**Minor Variance
Application**

A081/20

Property: **46 Cedar Glen Ct Kleinburg**

Purpose: Relief from By-law 1-88, as amended, is being requested to permit the construction of a proposed covered patio (canopy) located in the rear yard.

SURVEYOR'S REAL PROPERTY REPORT
 PLAN OF
LOT 2
REGISTERED PLAN 65M-2928
 CITY OF VAUGHAN
 REGIONAL MUNICIPALITY OF YORK
 SCALE 1 : 150

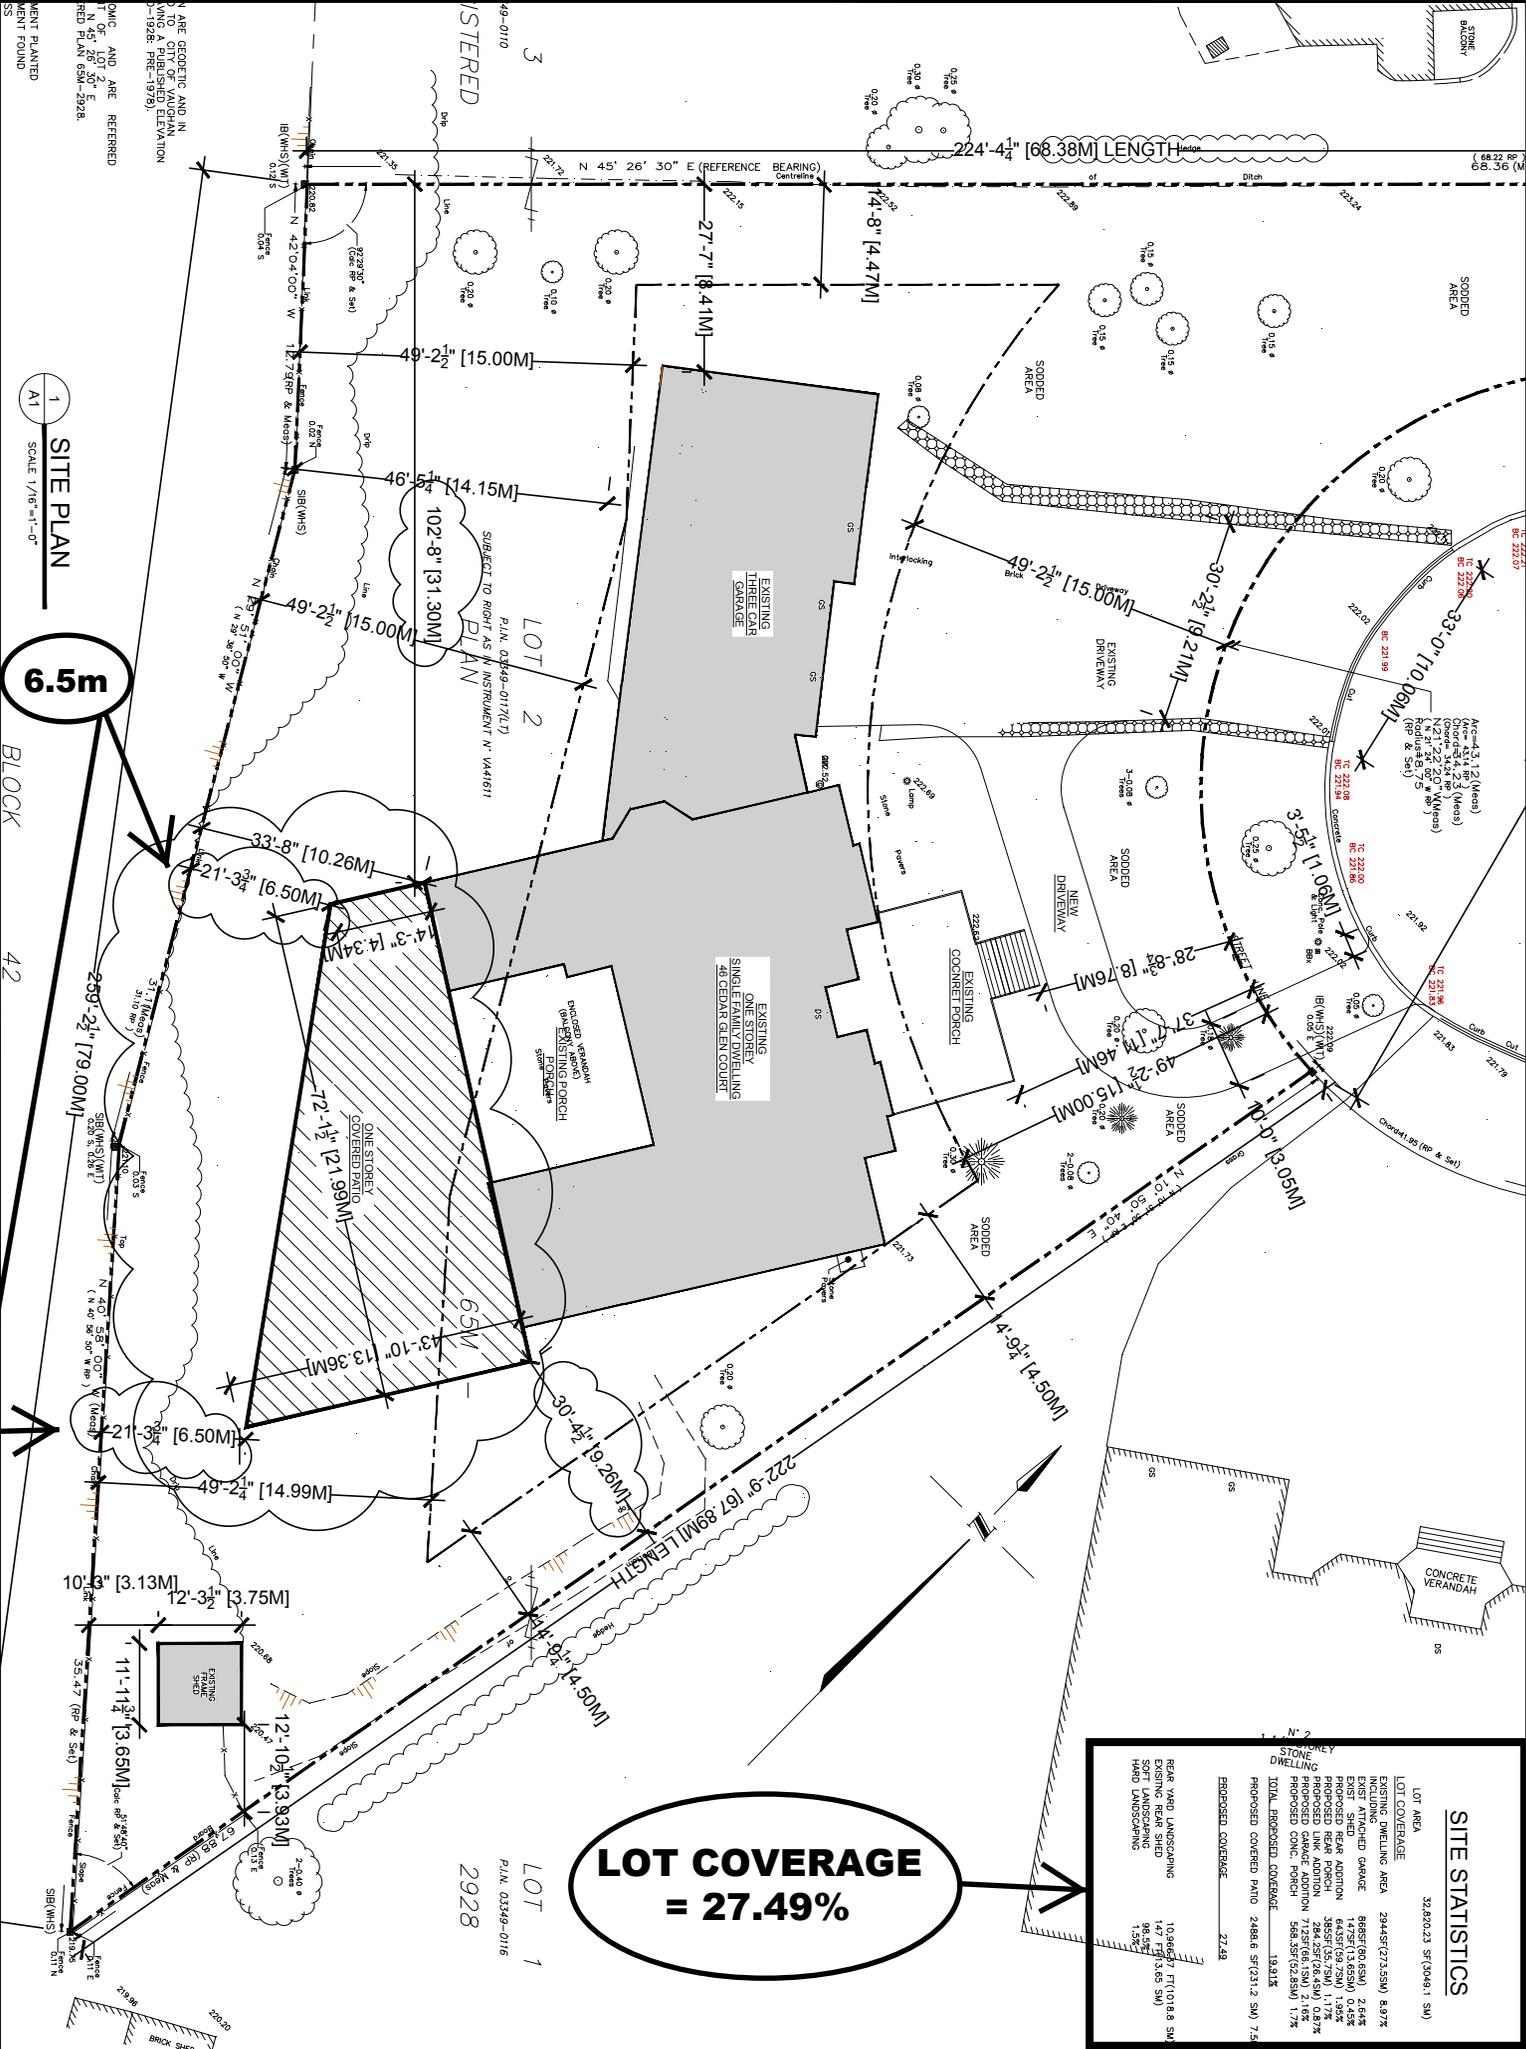
Minor Variance File A068/19 authorized a maximum lot coverage of 19.96% (19.51% dwelling and 0.45% shed). The covered patio addition contributes an additional lot coverage of 7.53%, resulting in an overall lot coverage of 27.49%. As the covered patio addition is located entirely in the rear yard and maintains sufficient setbacks from the interior lot lines, the additional coverage does not create undesirable impacts neighbouring properties given the size the lot and location of the covered patio. Development Planning Staff note that a small portion of the covered patio addition is partially visible from the cul-de-sac; however, due to the sloping grade away from the cul-de-sac toward the rear lot line, the covered patio addition complements the character of the dwelling, is suited for the lot and does not adversely impact the streetscape. As such, Variance 2 is considered minor in nature and desirable for the appropriate development of the lands.

The subject lands are partially located within Toronto and Region Conservation Authority's ('TRCA') Regulated Area due to the presence of a valley corridor associated with the Humber River. Development Planning staff note that the existing rear yard setback of the covered patio addition is 3.5 m. As TRCA policies require a minimum 6 metre setback from either the physical or long-term stable Top of Bank ('TOB') of a valley corridor for non-habitable accessory structures, the Owner has agreed to cut back the covered patio addition to maintain a minimum rear yard setback of 6.5m. Based on the proposed revision, the TRCA has no concerns with the proposed variances. As such, Variance 2 is considered minor in nature as the proposed setback will not impact the valley corridor or the neighbouring lots to the north and south.

Accordingly, the Development Planning Department is of the opinion that the proposal is minor in nature, maintains the general intent and purpose of the Official Plan and Zoning By-law, and is desirable for the appropriate development of the land.

1 REAR ELEVATION
 A9 SCALE 1/75

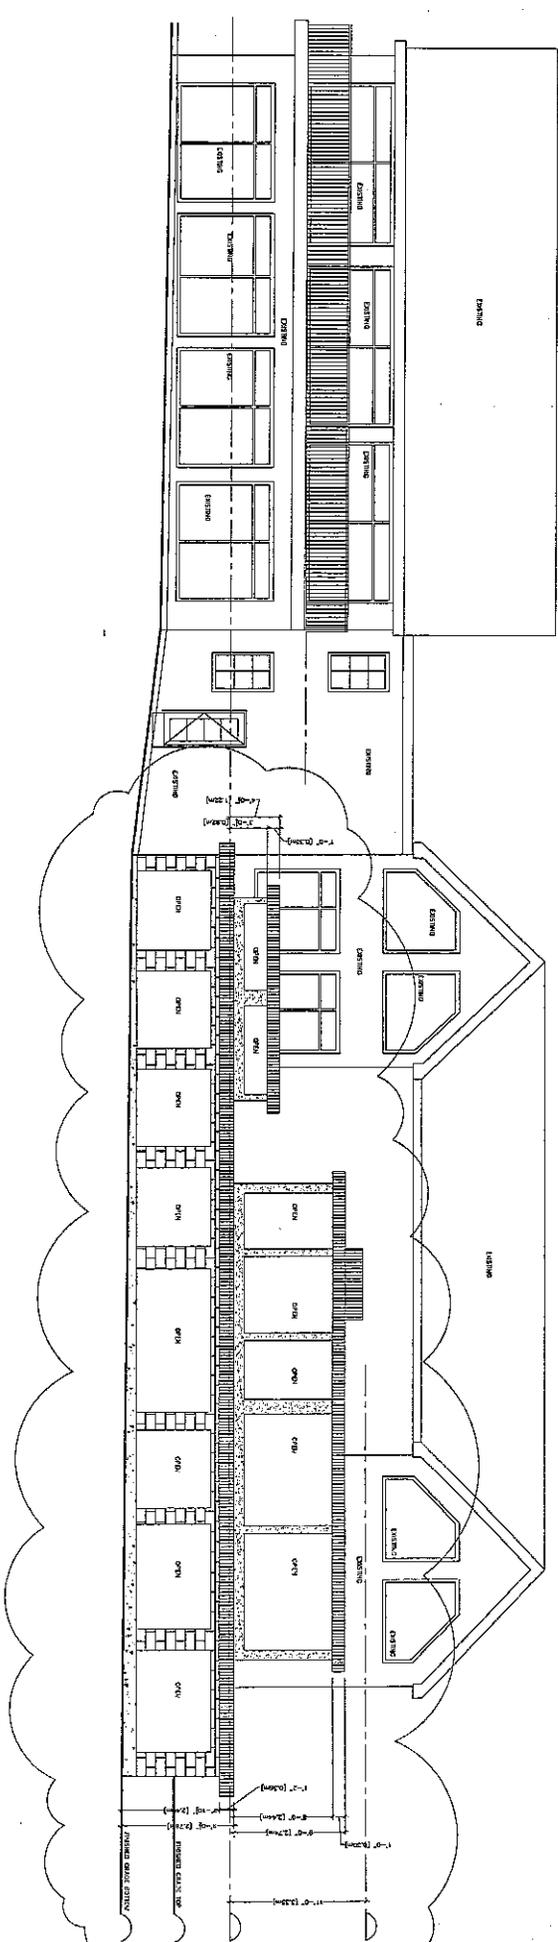
Development Planning staff attended the subject property on September 15th, 2020 and observed a dwelling under construction with a partially constructed covered patio addition in the rear of the property. The addition features several openings (with no glazing) around the perimeter at the ground level with access to the dwelling via sliding doors from the basement. The top of the covered patio is accessed from the main floor of the dwelling and is open and unenclosed.
